<b>Project Name</b>	COASTAL GASLINK PIPELINE Project	<b>Inspection Status</b>	Final
<b>EA Certificate #</b>	E14-03	<b>Inspection No.</b>	IR2021-014
<b>Project Status</b>	Certified	<b>Inspection Start</b>	2021-04-27
<b>Sector</b>	Energy	<b>UTM</b>	10U 533697 E 6071620 N
<b>Trigger</b>	Planned Inspection	<b>Inspection Type</b>	Field
<b>Project Description</b>	The Coastal GasLink Pipeline Project (Project) is an approximately 650 kilometer (km) long natural gas pipeline connecting facilities in northeast British Columbia (BC) to the LNG Canada facility near Kitimat.		
<b>Location Description</b>	The Project is near Groundbirch (40 km west of Dawson Creek) in northeast BC to the LNG Canada facility near Kitimat. This inspection covered portions of focused on work being carried out in Sections 1, 3, 4, 5, 6, 7 and 8 of the Project.		
<b>Inspection Summary</b>	<p>From April 27 to May 6, 2021 Environmental Assessment Office (EAO) Director of Compliance and Enforcement Chris PARKS and Senior Compliance and Enforcement Officer Clayton SMITH (collectively EAO C&amp;E) inspected the Coastal GasLink Pipeline Project (Project) against requirements of the Environmental Assessment Certificate (EA

Photo 7. Section 3, approximately KP214+804, S3 High chain sump draining through filter bag. Water from bag then flows back towards and into S3 stream.

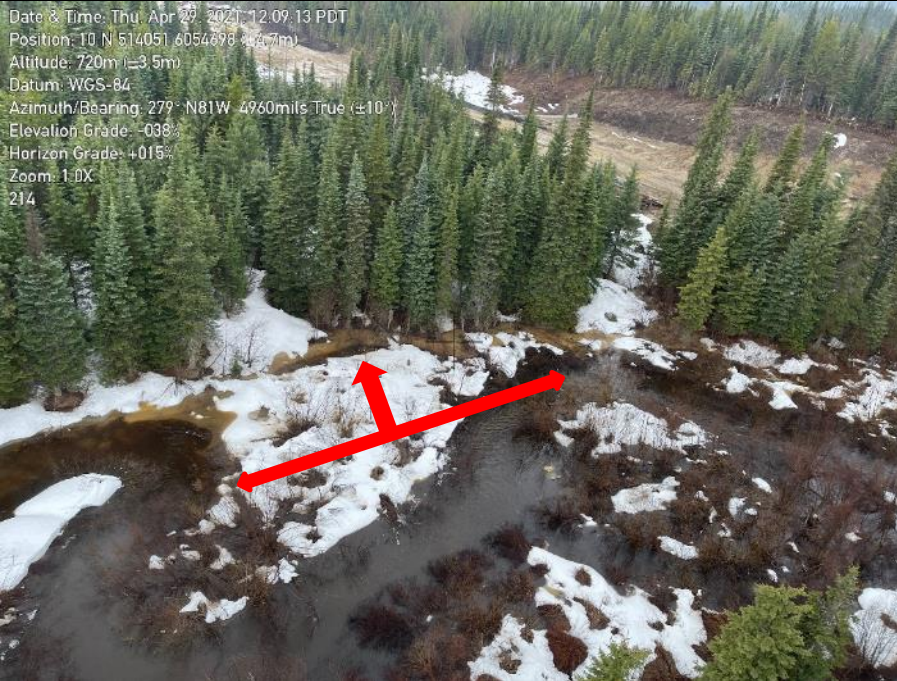
- KP 214+804 (S3). Sediment laden water leaving RoW and entering channel. High chain sump draining through filter bag. Water from filter bag then flows back towards and into S3 stream.

Photo 30. Sediment leaving right of way and draining towards wetland WL11553 near KP227+733.

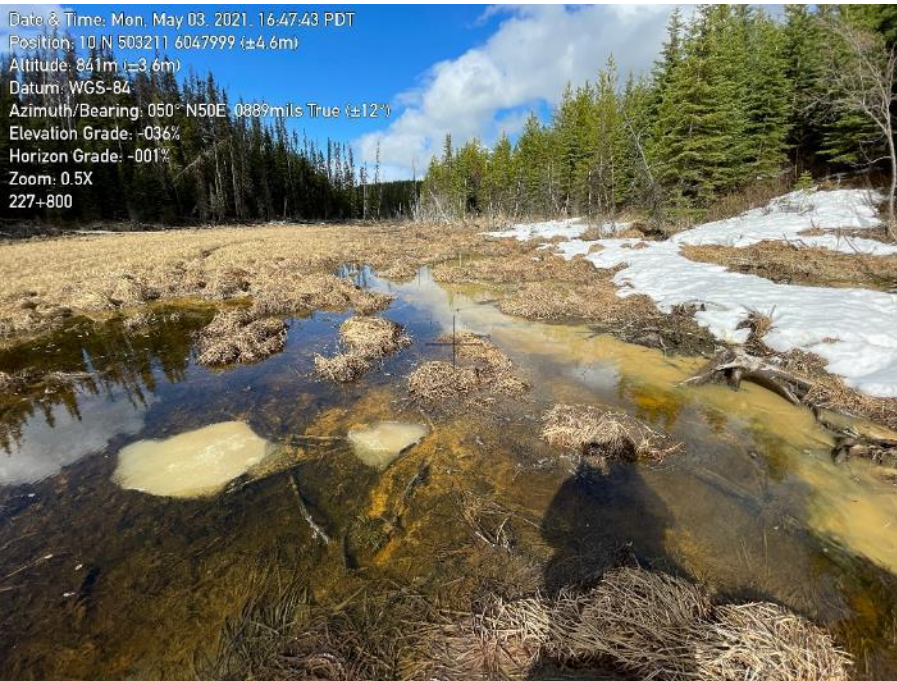
- KP 227+800 (S1B), watercourse 110C, wetland # WL11553 (ESIW). Sediment laden water from RoW transported material into watercourse. Sediment deposition observed within the watercourse at the crossing location. Additionally, surface materials from the RoW on the high chain side of the crossing were observed leaving the Project site and actively transporting downslope into the watercourse / wetland upstream of the bridge crossing while EAO C&E was on site.
- KP229+100. NCD type feature crossing the RoW observed to have sediment laden water within. As feature leaves the RoW failed ESC measures are present. Sediment deposition off the RoW observed. Pooled sediment laden water from this location also observed off the RoW.
